Enbridge

July 31, 2025

**RE: Texas Eastern Transmission, LP
Notice of Amendment
CPF 3-2025-028-NOA**

Figure 1 - Yield Strength Distribution for 24,000 SMYS

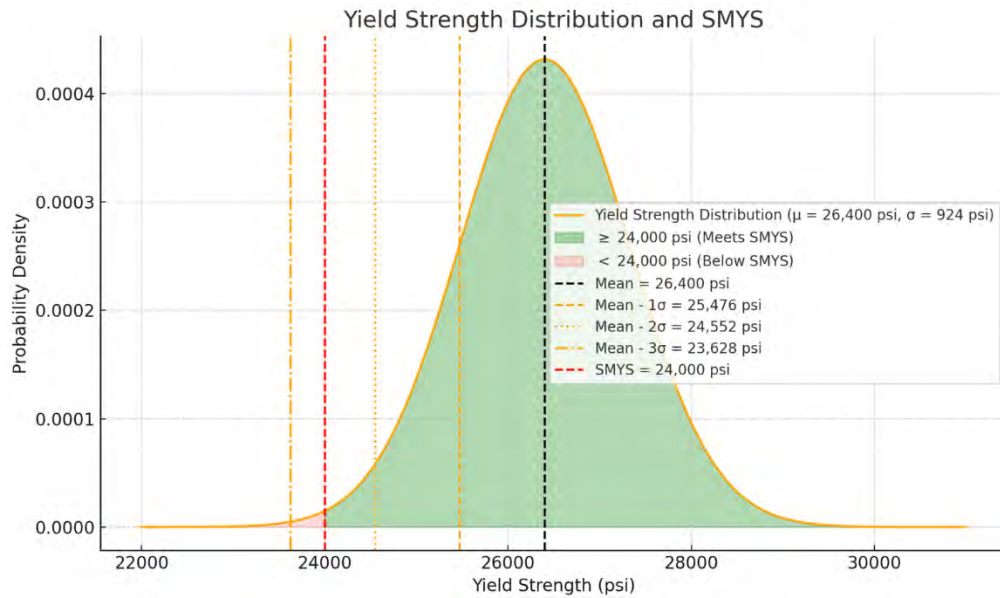
TET's procedure AI-72.800 – Asset Integrity Risk Algorithm Document Guide did not require the use of the values upon which the current MAOP was based upon as inputs for the risk analysis used to determine the predicted failure pressure. The procedure did not require the use of the material properties for which the MAOP was based upon if traceable, verifiable, and complete records are unknown. Appendix C – *Default Uncertainty Distributions* of the document contains the default uncertainty values used for the analysis. Table C.4 – *Material Tensile Properties* lists the Specified Minimum Yield Strength (SMYS), the Mean, and the Standard Deviation for the yield strength and tensile strength for each grade of pipe. In the table, PHMSA noted that the mean values taken with the standard deviation would exceed the SMYS value utilized to establish the MAOP. For example, the table indicates for Grade 24000 psi pipe, there is a mean of 26400 psi and a standard deviation as 924 psi. The lowest value that could be used is 25476 psi ($26400 - 924 = 25476$), which is greater than 24000 psi SMYS. During the inspection, TET personnel indicated that the mean values, which all exceed the SMYS, are used as inputs in the analysis. As a result, there appears to be a conflict with PI-04.505 Section 7.3.2.1 which states that the values which the current MAOP is based upon

must be used when calculating predicted failure pressures. Therefore, TET's procedure in AI-72.800 did not meet the requirements of § 192.712(e)(2)(iii) as required by § 192.605(a).

The assertion is that TETLP AI-72.800 does not meet the requirements of §192.712 (e)(2)(iii)¹, which must be applied until material properties are available. PI-04.505 requires the use of Specified Minimum Yield Strength (SMYS) to calculate predicted failure pressure and schedule anomaly response, relying solely on SMYS in a deterministic manner.

In contrast, AI-72.800 employs a risk-based, probabilistic approach that accounts for all uncertainties, including yield strength, and consequences such as structure density. While PI-04.505 considers only SMYS, AI-72.800 evaluates the full range of probable yield strengths for the applicable grade, as illustrated in Figure 1. By incorporating multiple standard deviations, the assessment captures tail risks, including low-probability values that fall below SMYS.

This illustrates that even though most values are near the mean, there is always a non-zero probability of more extreme results. For example, a small portion of values will fall below the SMYS of 24,000 PSI, even if the mean is 26,400 PSI.
